**Development Special Use Permit with Site Plan #2006-0018**  
**Coordinated Sign Program SUP #2008-0089**  
**Potomac Yard – Landbays I & J**

POTOMAC YARD  
LANDBAYS I & J - DSUP #2006-0018  
2001 MAIN STREET AND 2301 MAIN STREET

DSUP #2006-0018  
COORDINATED SIGN PROGRAM  
SUP #2008-00089

## Attachment #8

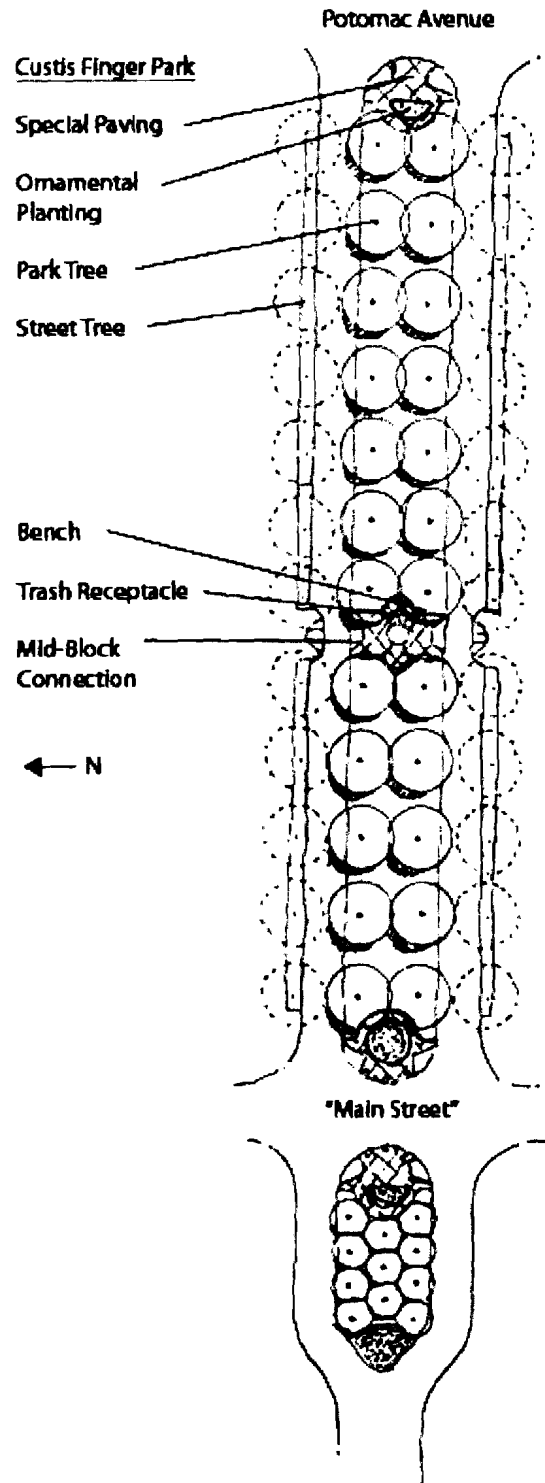
11. ***Custis Finger Park:*** The park shall be revised to provide the following to the satisfaction of the Directors of RP&CA and P&Z:
- a. The park shall be revised as generally depicted in Attachment # 8.

- b. Revise the spacing of the park trees to 30 feet on center, as approved in DSUP 2004-0048, and provide an additional four (4) shade trees. Street trees along Custis Avenue shall be parallel the length of the street.

- c. Provide eleven (11) ornamental trees in the portion of the finger park west of Main Street.
  - d. Freestanding signage shall be prohibited.
  - e. Two City standard trash receptacles shall be provided within the park.

## Attachment #9

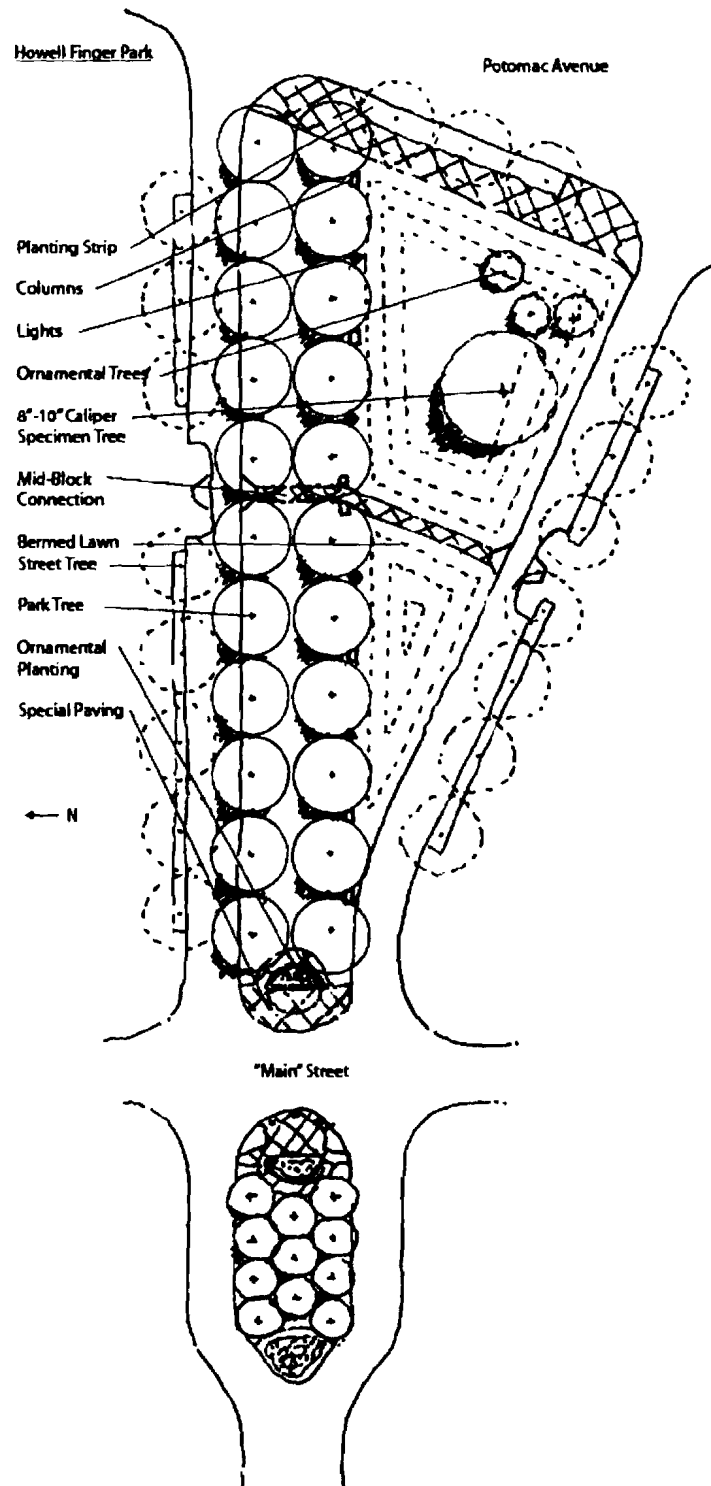
12. ***Howell Finger Park:*** The park shall be revised to provide the following to the satisfaction of the Directors of RP&CA and P&Z:
- a. The park shall be revised as generally depicted in Attachment # 9.

- b. Revise the spacing of the park trees to 30 feet on center to provide an additional fourteen (6) shade trees.

- c. Provide eleven (11) ornamental trees in the portion of the finger park west of Main Street.
  - d. Freestanding signage shall be prohibited.
  - e. Benches shall be provided within the park.
